# Access Compliance Report

## Public Rights-of-Way

### (Curb Ramps)

Intersection ID: 41209	Main Street: SACKETT_WY	Cross Street: CLYMER_CT	Location: SE
ADA ID: 927C641787F5	Ramp Type: PerpDiag	Initial Pass/Fail: Fail	Overall Compliance: No
		Severity Score: 25

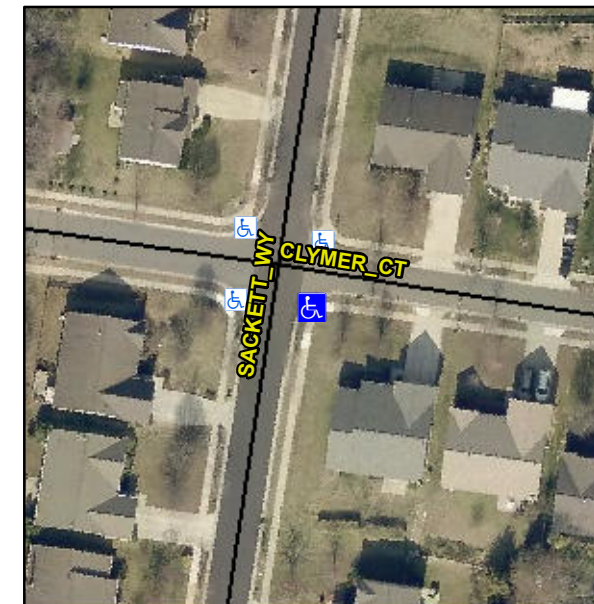
**Not Found, R304.5.3**

Compliance	Description	Data	Compliance	Description	Data
N/A	Ramp Length (in)	48.0	Yes	Ramp Slope (%)	5.1
Yes	Ramp Width (in)	96.0	No	Ramp XSlope (%)	11.8
N/A	Flare Type LT	N/A	N/A	Flare Type RT	N/A
N/A	Flare Slope LT (%)	N/A	N/A	Flare Slope RT (%)	N/A
N/A	Flare Traversable LT?	N/A	N/A	Flare Traversable RT?	N/A
N/A	Landing Length (in)	N/A	N/A	DWS Provided?	N/A
N/A	Landing Width (in)	N/A	N/A	DWS Contrast?	N/A
N/A	Landing Slope (%)	N/A	N/A	DWS Length (in)	N/A
N/A	Landing X Slope (%)	N/A	N/A	DWS Full Width?	N/A
N/A	Landing Curb? (Y/N)	N/A	N/A	DWS Offset (in)	N/A
N/A	Shared Landing?	N/A			
N/A	Gutter Ponding?	N/A	N/A	Gutter Slope (%)	N/A
N/A	Gutter Lip Ht (in)	N/A	N/A	Gutter X Slope (%)	N/A
N/A	Painted X Walk1?	No	N/A	Painted X Walk2?	No
	X Walk 1 Direction	To N		X Walk 2 Direction	To W
N/A	X Walk 1 Width (in)	N/A	N/A	X Walk 2 Width (in)	N/A
	X Walk 1 Slope (%)	4.5		X Walk 2 Slope (%)	1.5
	X Walk 1 X Slope (%)	2.7		X Walk 2 X Slope (%)	3.7

**Remove & Replace Curb Ramp With Two New Directional Ramps or Equivalent.**
